Land at Downlands Farm, Uckfield

Highways and Transport Evidence on behalf of Gleeson Land and John Alison Land and Research Ltd

PINS Reference: APP/C1435/W/23/3321978
LPA Reference: WD/2022/1637/MEA

Response to ESCC Highway Comments

Drawing: 2001061-102

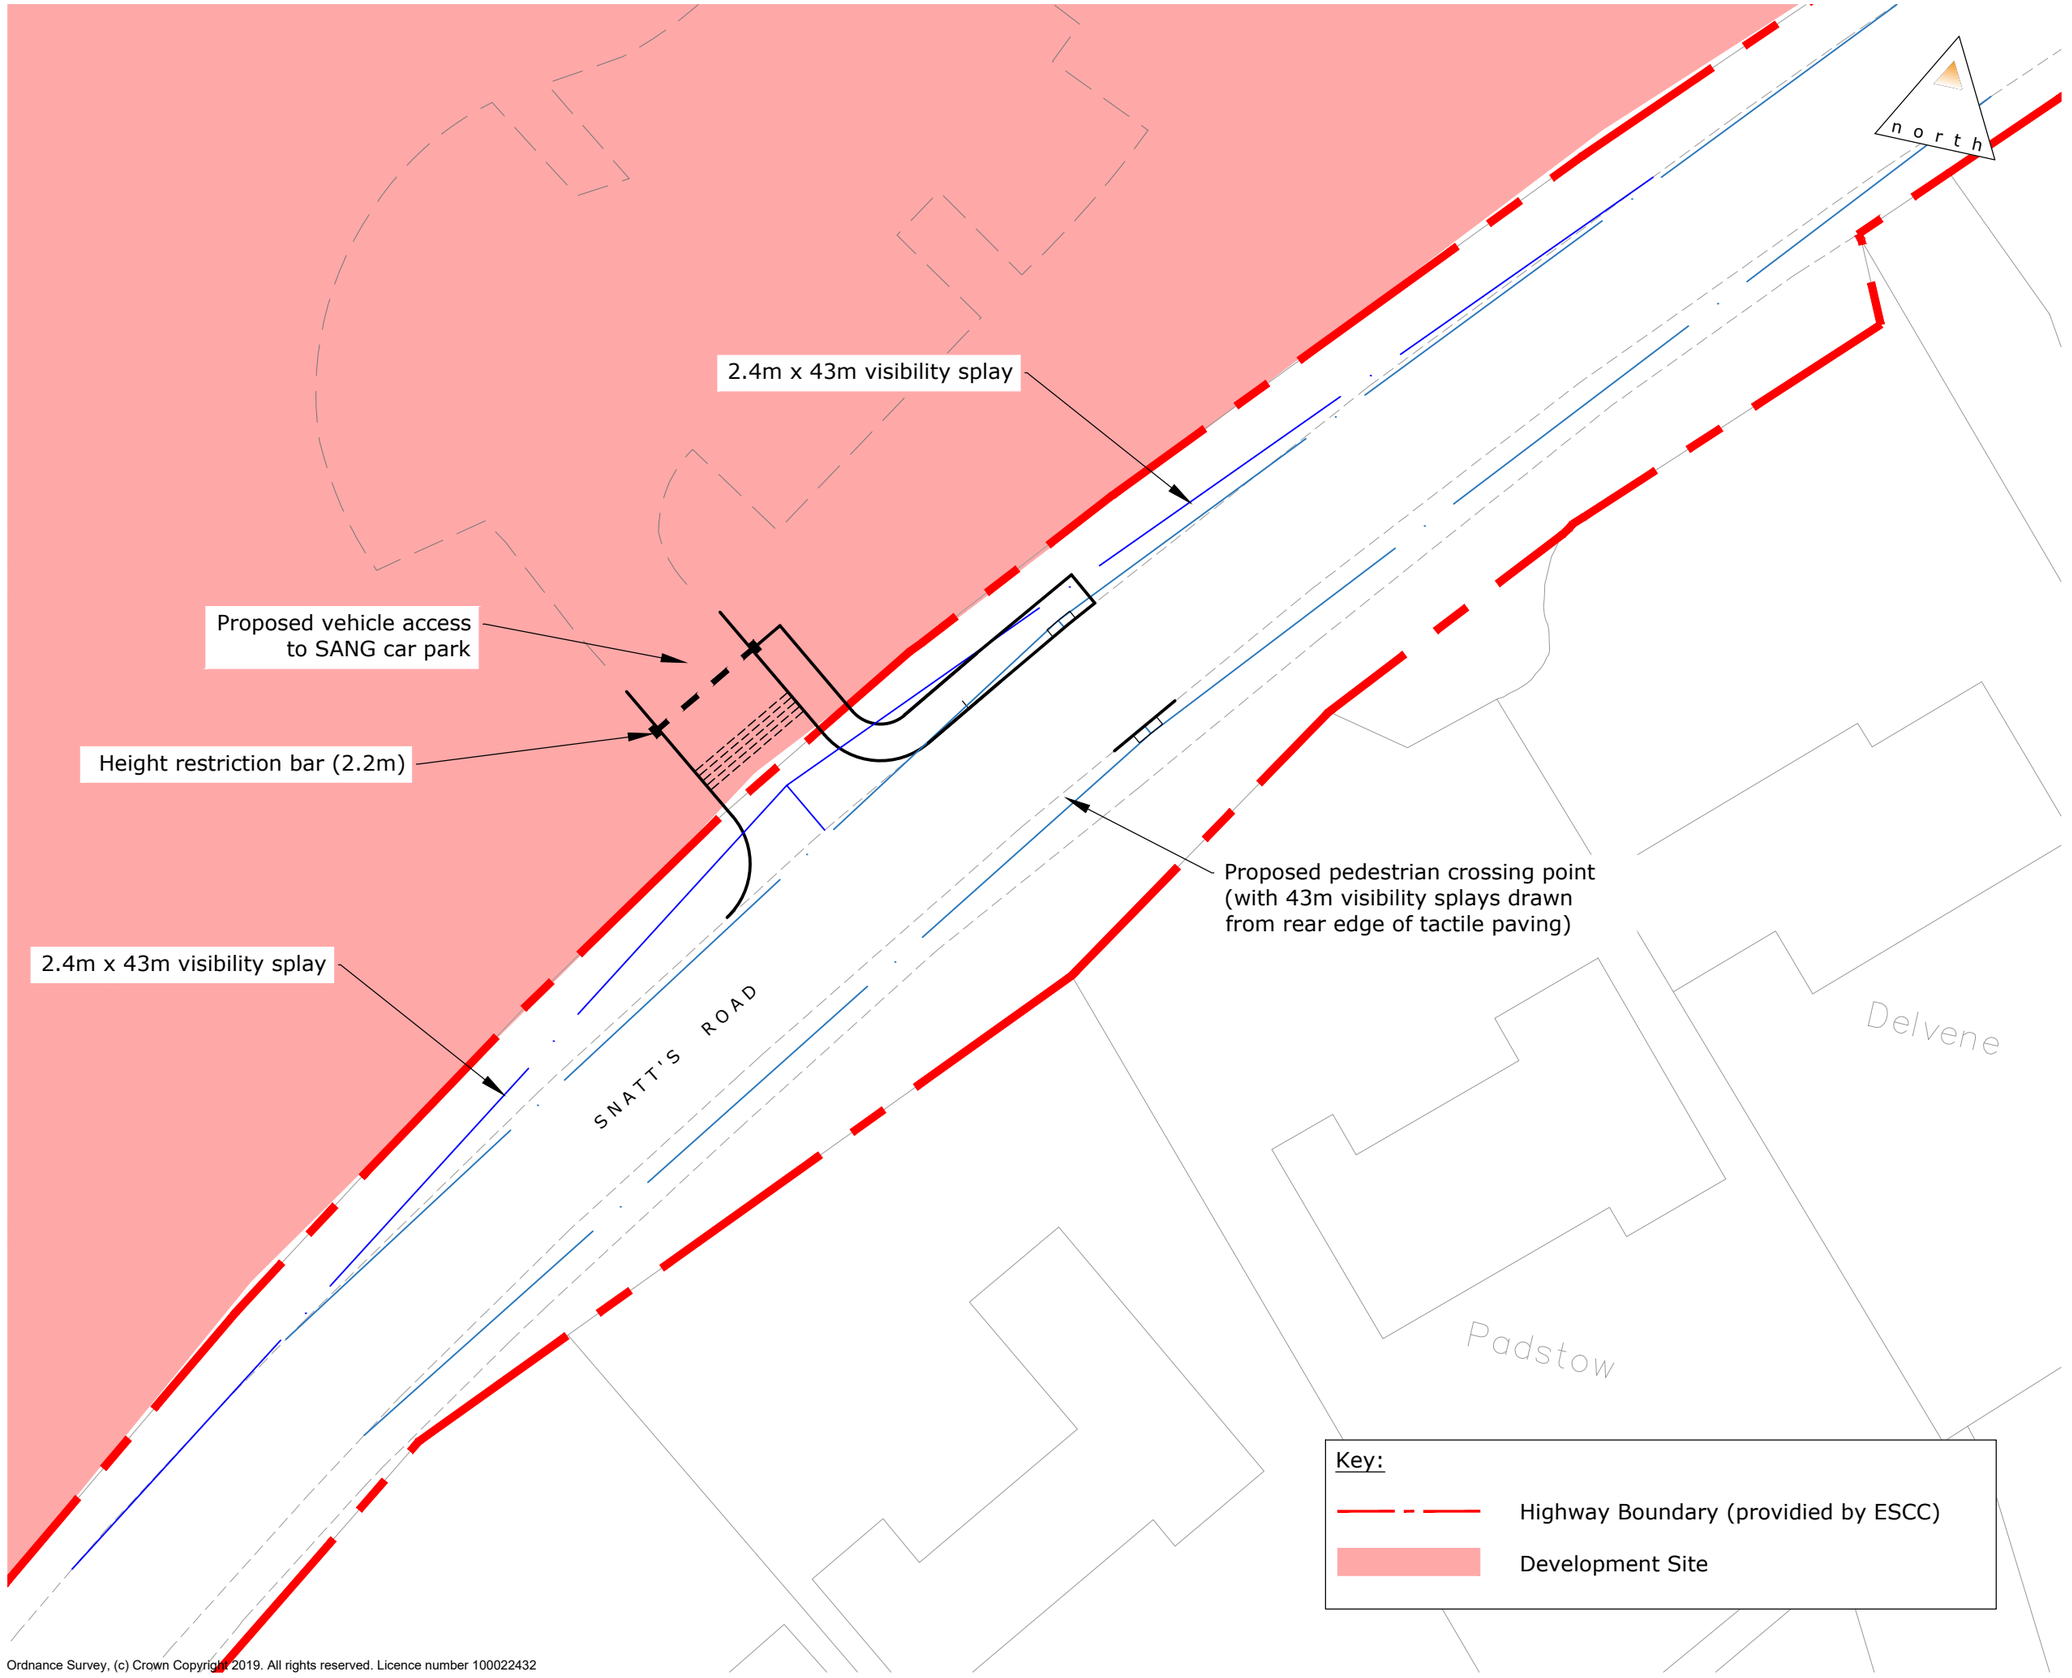
ESCC Comments relating to: Drawing 2001061-102 - Emergency Access		
Date	ESCC Comments	*Motion Response*
2022 Oct	Risk of shunts vehicles following emergency vehicles may not be expectant of the vehicle ahead of them to turn upon entering the layby. There will be no way to signal this manoeuvre.	2022 Dec *Relates to Motion drawing 2001061-102* The emergency access is located on the entry to the layby. This is off the main A22 carriageway so any vehicles following would also be intending to enter the layby and would therefore be decelerating accordingly. It should also be noted that the use of this access will be infrequent. In the event that an emergency vehicle is accessing the site under blue light conditions, other road users will be aware of the blue lights, indicating that the emergency vehicle is responding to a call. In this situation other nearby road users would use additional caution.

2022 Oct	The radius of the access will require a low-speed entry which may not be appropriate for high speeds of emergency vehicles	2022 Dec *Relates to Motion drawing 2001061-102* The radius at the access is 6 metres. This is typical of residential bellmouth junctions that emergency vehicles are typically required to manoeuvre through. It is considered to be sufficient to accommodate safe turning manoeuvres by emergency vehicles whilst minimising impact on the adjacent area designated as Ancient Woodland. Greater radii could be achieved without encroaching on the adjacent Ancient Woodland boundary, should this be necessary.
2022 Oct	It is questioned if there is sufficient length ahead of the barrier for a vehicle to wait.	2022 Dec *Relates to Motion drawing 2001061-102* Drawing has been revised to provide a clearance of 12 metres minimum length for emergency vehicles to stop in front of the barrier, without obstructing the layby entry slip road. *Drawing 2001061-102 has been amended to revision C*

2022 Oct	Are visibility splays exiting reliant on maintenance of vegetation?	2022 Dec *Relates to Motion drawing 2001061-102* Drawing 2001061-102 shows a 215 metre visibility splay at the emergency access, which would require trimming / clearing of roadside vegetation.

2022 Oct	Signing would need to indicate westbound only on exit.	2022 Dec *Relates to Motion drawing 2001061-102* Agreed, note added to drawing 'turn left' sign to be installed. Details to be confirmed at detailed design stage. *Drawing 2001061-102 has been amended to revision C*

2022 Oct	Layby should be upgraded to modern standard	2022 Dec *Relates to Motion drawing 2001061-102* It is not clear how this relates to the development proposals. Notwithstanding this, the extent of highway land and proximity to adjacent land designated as Ancient Woodland would be likely to make any widening or extension to the layby impractical; however, this can be considered further at the detailed design stage.
2023 Mar	Emergency Access – clear marking required to ensure that the access position remains unobstructed. The position is the only point this access could go on grounds that it is surrounded by ancient woodland. Agreed that there is unlikely risk of shunts though it should be ensured that an appropriate radius for entry is available for approaching vehicles at emergency speeds. Also, markings on the layby should be provided to ensure that the access and the area required for turning remains unobstructed when layby is used by resting drivers. This element of the site cannot be used as a regular vehicle route by vehicles such as buses due to ecological constraints (ancient woodland).	2023 May *Relates to Motion drawing 2001061-102 rev C* The emergency access has a 6m radius, which the designer considers to be suitable. It is arranged as a minor access off the layby, and there similar to other emergency accesses that are provided to serve developments. The drivers of emergency vehicles will be decelerating as they enter the layby and have a responsibility to drive at speeds that are appropriate for the road layout. It is common for emergency access routes to have a dropped / splayed kerb and lockable bollard, as is proposed at this location. Emergency vehicles will be required to stop at the access and will not be attempting to pass through the junction at inappropriately high speeds. The drawing has been revised to include 'keep clear' marking. ***Drawing 2001061-102 has been amended to revision D***

2023 Jun	TECHNICAL TEAM COMMENTS: The proposed bollards/gate are set too far back from the highway boundary with a risk that 'fly tipping' may take place.	2023 Jul *Relates to Motion drawing 2001061-102 rev D* The bollard set back distance is required to accommodate emergency vehicles stopping clear of the slip road, whilst the bollard is removed. The bollard location is not considered to have an influence on the likelihood of fly-tipping at this location.

Drawing: 2001061-104

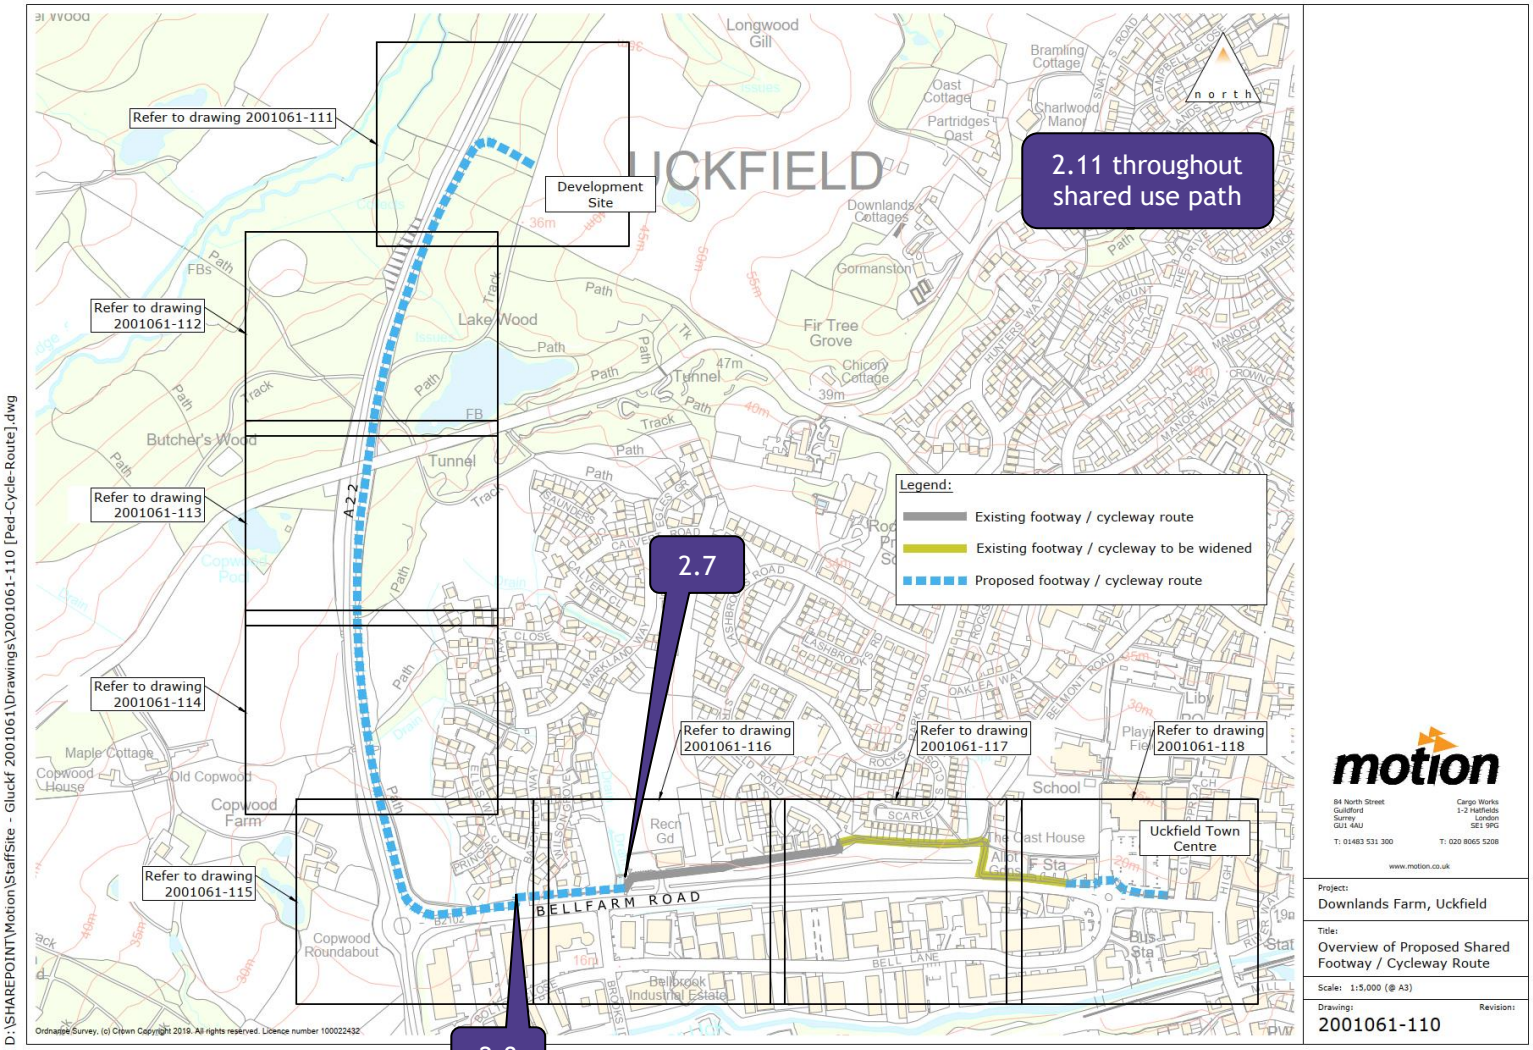
ESCC Comments relating to: Drawing 2001061-104 – ProW Route		
2022 Oct	Figure 1.1 in the consultant's Community Bus Service note shows the position of bus stops on the existing nearest bus route serving The Drive (northbound) and Manor Way (southbound). The most westerly bus stop on each of these roads are adjacent to the off-site highways works (which are proposed to include drop kerbs and tactile paving) in relation to the pedestrian route improvements (drawing 2001062-104). We ask that a raised bus stop kerb and bus stop clearway markings are provided for each of these two bus stops.	2022 Dec *Relates to Motion drawing 2001061-104* This request has been incorporated into the proposals, the drawing has been revised to include the provision of raised kerbs and bus cage markings at the two existing bus stops. *Drawing 2001061-104 has been amended to revision A*
2022 Oct	Installation of suitable signage along existing public footpaths to core destinations; Comments: details of signage has not been provided.	2022 Dec *Relates to Motion drawing 2001061-104* Pedestrian wayfinding signs will be blue and white style sings in accordance with schedule 12 of the TSRGD. Sign face details and mounting locations to be specified at detailed design stage as part of the off-site highway works package.

2022 Oct	Suitability of lighting for highway safety and security within the greener areas of the site are dependent on ecology comments, which may define whether some routes are in fact reliable active links to the site.	2022 Dec *Relates to Motion drawing 2001061-104* With regard to the existing routes through the existing residential estate (as indicated on drawing 2001061-104), the provision of lighting will be considered further as part of detailed design, taking account of any ecological requirements. It is understood that ESCC already apply a 'part night lighting scheme' where lighting is dimmed or switched off during certain hours, which could be applied in this instance should there be an ecological concern.

2022 Oct	C-D-E (footpath at rear of Hunters Way) There is clearly an error on the proposal plan where it labels this section as 'Existing asphalt footpath: Inspect surface condition and repair defects or resurface as required'. This is a narrow section of unsurfaced footpath running between the rear gardens of the properties on Hunters Way and The Mount.	2022 Dec *Relates to Motion drawing 2001061-104* The drawing has been corrected to show that the existing unmade footpath surface is to be improved. The specification for PRoW path improvements can be agreed alongside the detailed design approvals for the off-site highway works package. *Drawing 2001061-104 has been amended to revision A*
2022 Oct	A tarmac surface for this section is likely to be problematic, due both to the width and likely root heave from the row of trees along the boundary of the properties on The Mount. I would suggest that this section could also be improved with a semi bound surface, if that is the choice for the woodland path (B-C). Although this section is considerably less steep, a rural surface of compacted stone may be sufficient. However, again, we would not want timber edging. For a short section at point D edging may be unavoidable, where the path has a severe camber and is badly affected by tree roots.	2022 Dec *Relates to Motion drawing 2001061-104* In light of these comments, drawing 2001061-104 has been amended to add reference to the suggested HBM surfacing material. The specification for PRoW path improvements can be agreed alongside the detailed design approvals for the off-site highway works package. *Drawing 2001061-104 has been amended to revision A*

Drawing: 2001061-113

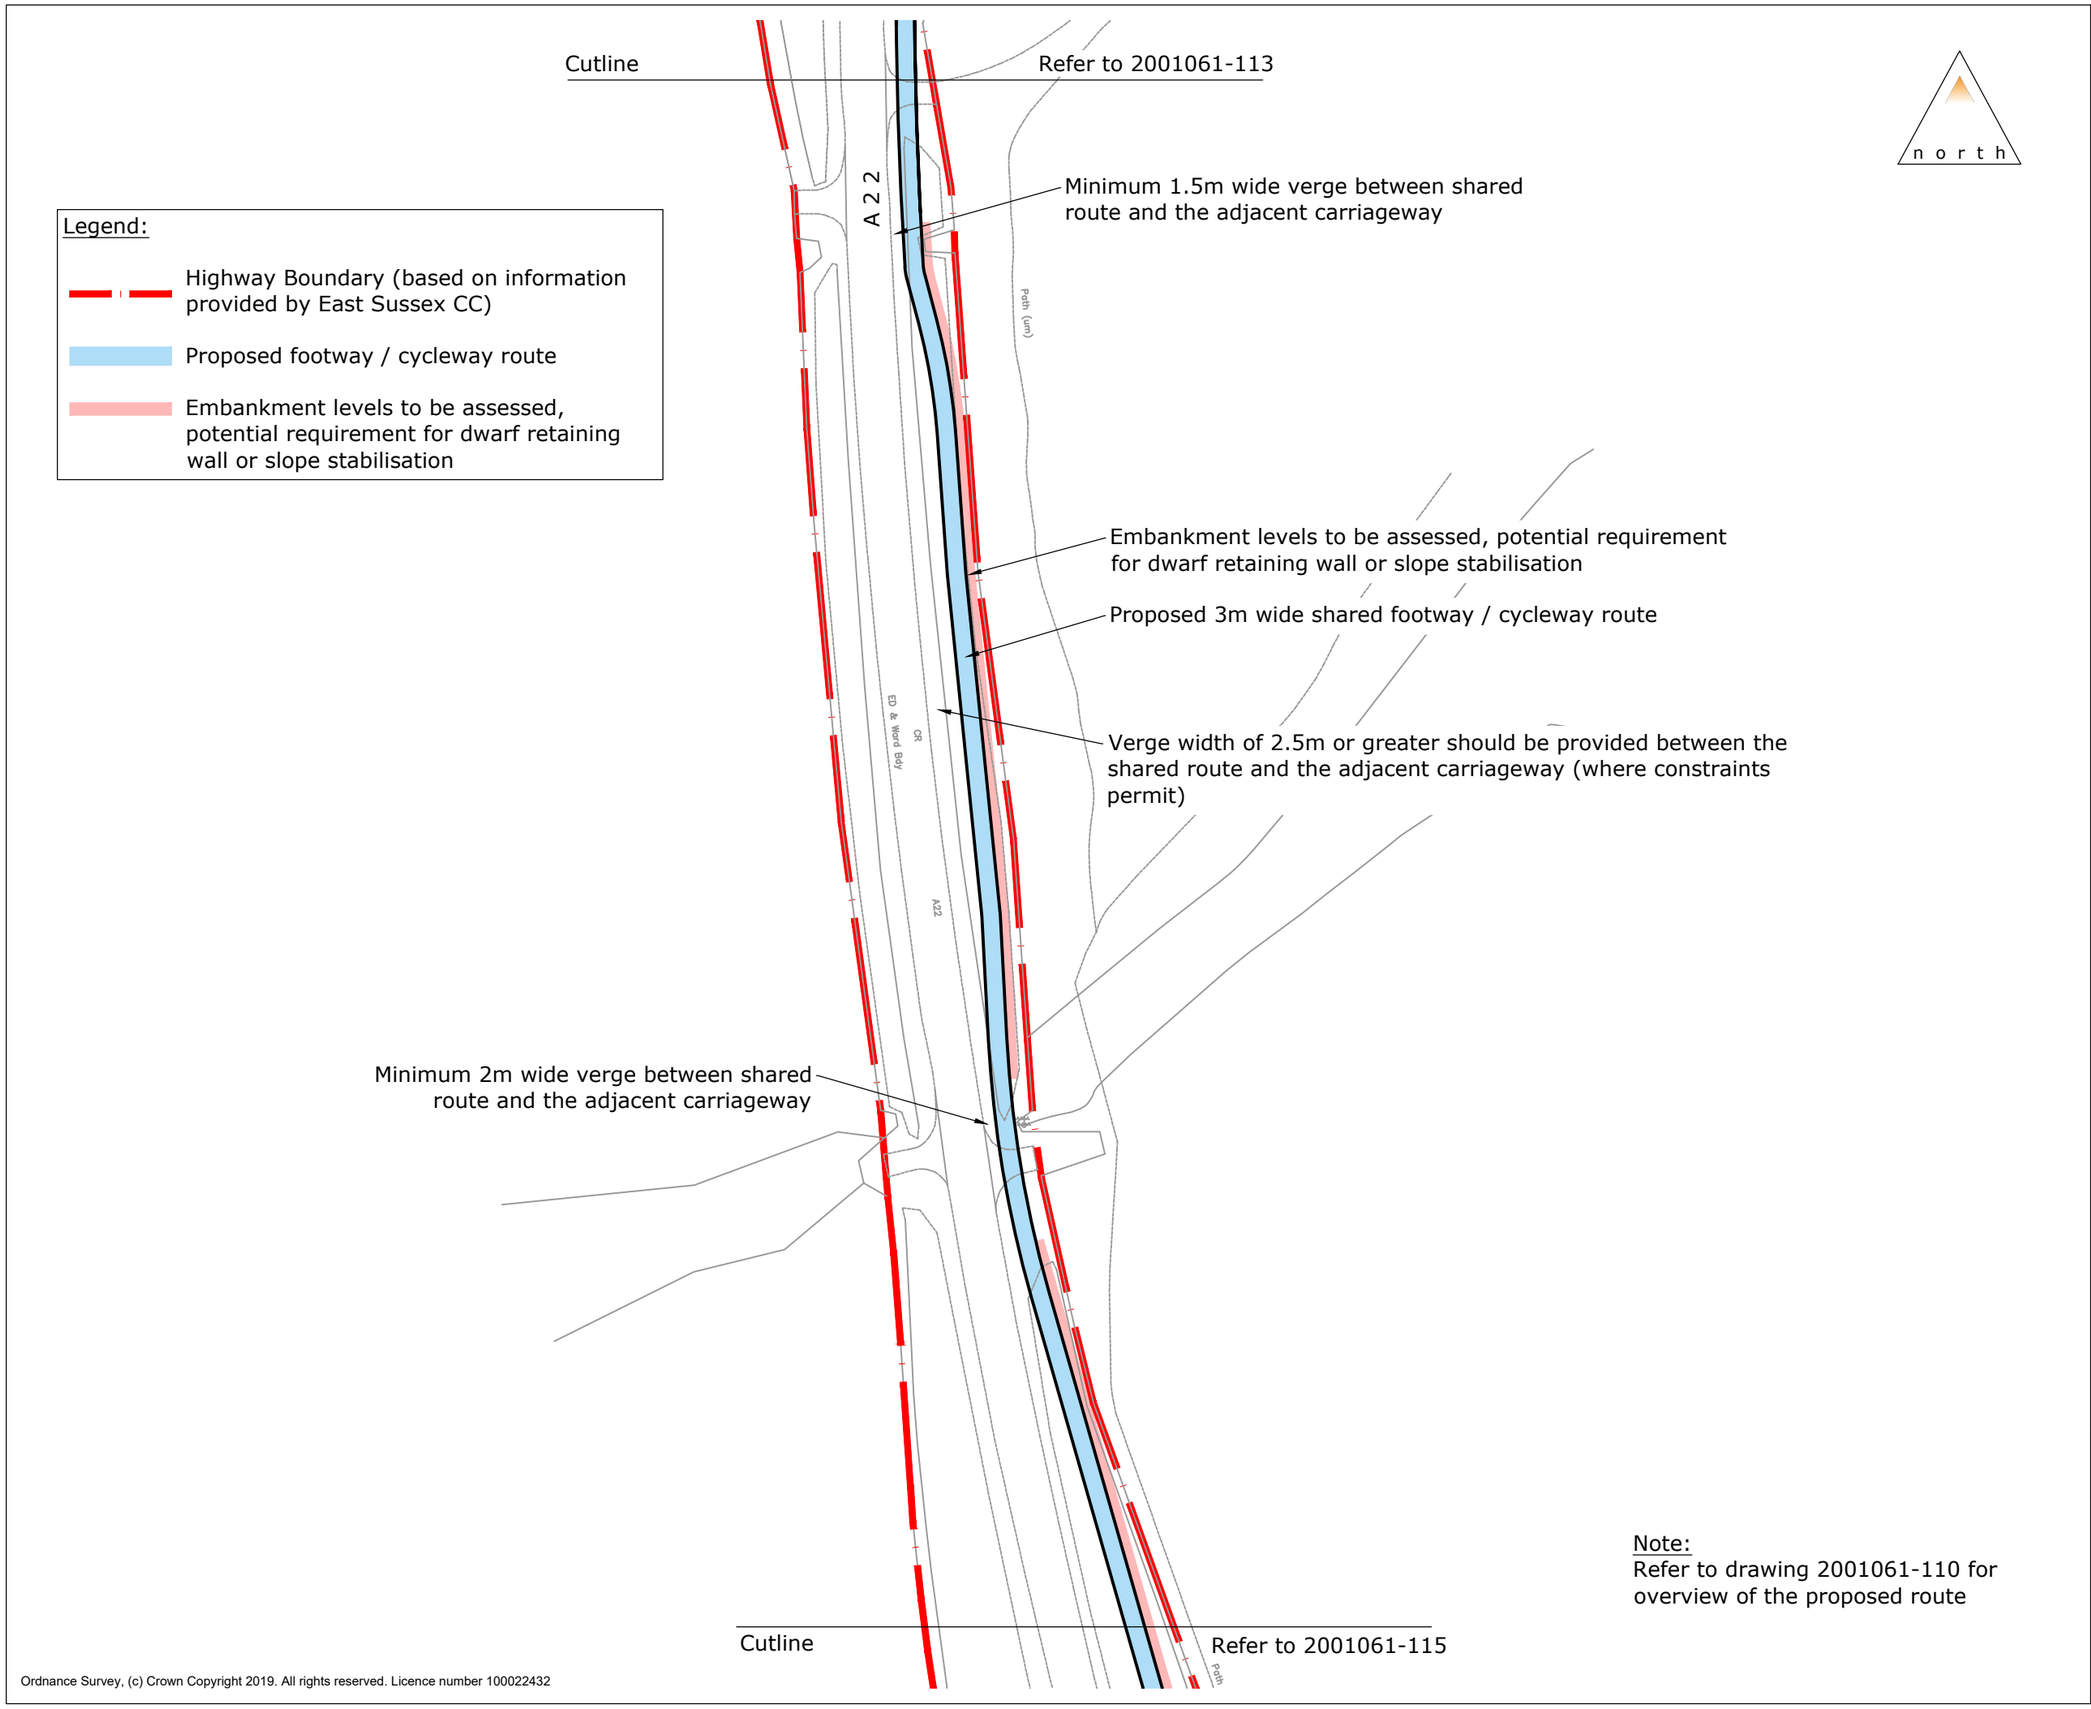
2022 Oct	Rocks Road overbridge narrowing (from 3 to 2 metres) over a longer distance than is recommended.	2022 Dec *Relates to Motion drawing 2001061-113* The length of the narrowed 2 metre wide section at the Rocks Road bridge has been reduced (drawing 2001-061-113 has been revised accordingly). The majority of the facility is 3 metres wide and only reduces to 2 metres where there are physical constraints (it is understood that a 2 metre wide shared footway / cycleway has been accepted as part of the Gridserve proposals). *Drawing 2001061-113 has been amended to revision B*
	Various traffic signs located within the highway verge where shared route is proposed, will need to be re-sited/ raised ensuring they remain within the optimum sight range for drivers.	2022 Dec *Relates to Motion drawings 2001061-111 to 2001061-116* It is acknowledged that as part of the detailed design stage, there will be a need for signs to be raised to 2.4 metres clear height above ground or relocated as appropriate.
